PERMIT

SEWAGE DISPOSAL SYSTEM 04-343999

HOWARD COUNTY HEALTH DEPARTMENT COMPLIANCE

SUBDIVISION Timberleigh Ridge LOT 8 ROAD 17525 Timberleigh Way

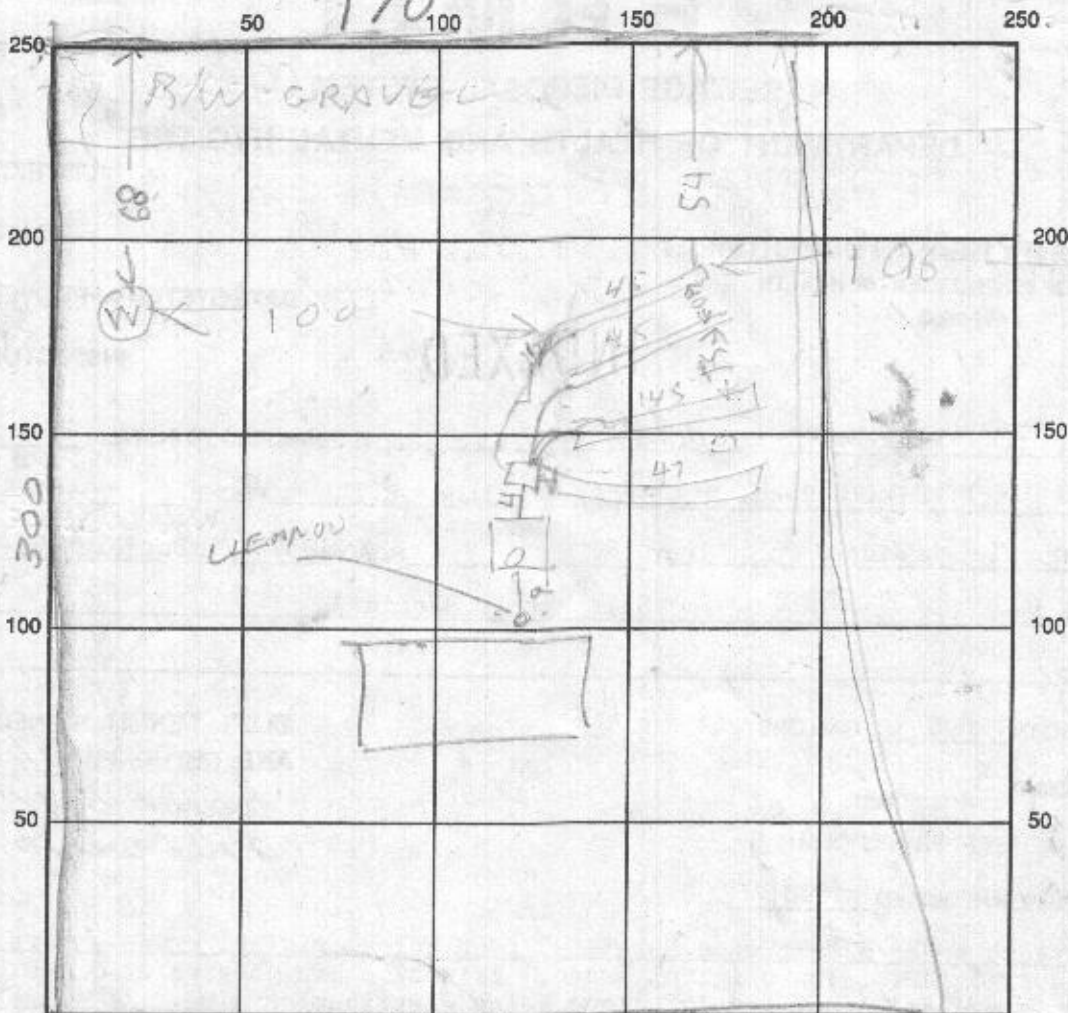
LOT IS ALMOST LEVEL OK/CW

RUN TRENCHES IN ANY DIRECTION BUT ON LEVEL GROUND
OK TO VARY DISTANCE BETWEEN TRENCHES

TO AVOID TREES 7/10/92 RH

Site Plan for:
 17525 Timberleigh Way
 Lot 8 of Timberleigh Ridge
 Plat 6337 dated 8/23/85

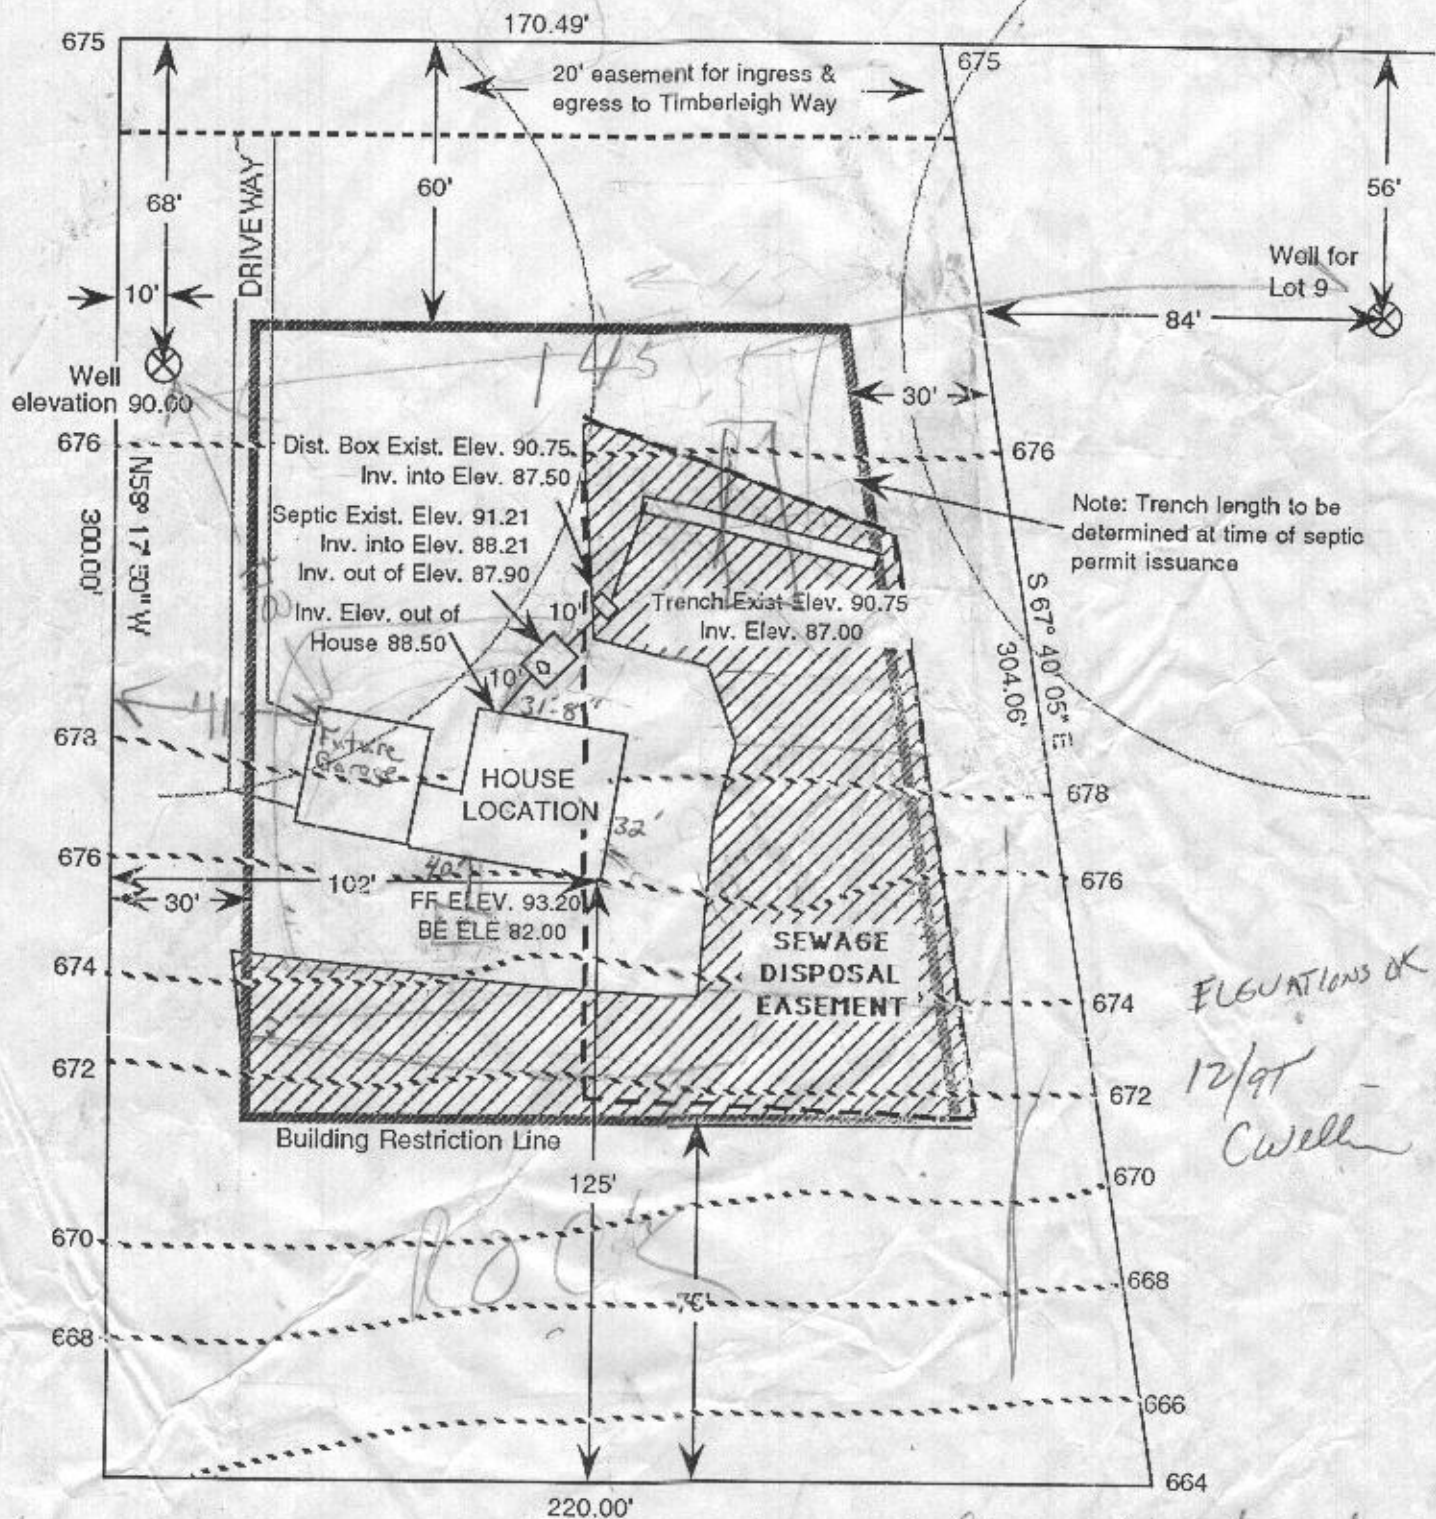
4/14/92 - met with owner who disabled septic Local

I said I must dis. cur. with CW
 Several options consider

① Put tank on front run pipe around House
 to Blue Hole on Back

or ② Use 2 tanks 1 for Basement toilet & 1 for Front

- (3) Use Leaching Bed to put system in confined area near Pen 1
- (4) Make Shallow Trenches with wider trenches than 3 ft

(1) LEACHING BED - NO

(2) 3 TRENCHES 4' WIDE - 45' LONG OK

(3) RE-ORIENTATION OF TRENCHES OK IF ELEVATIONS ARE "CLOSE" AS DETERMINED BY TRANSIT

(4) 2 SYSTEMS OK

(5) PUMPED BASEMENT OK
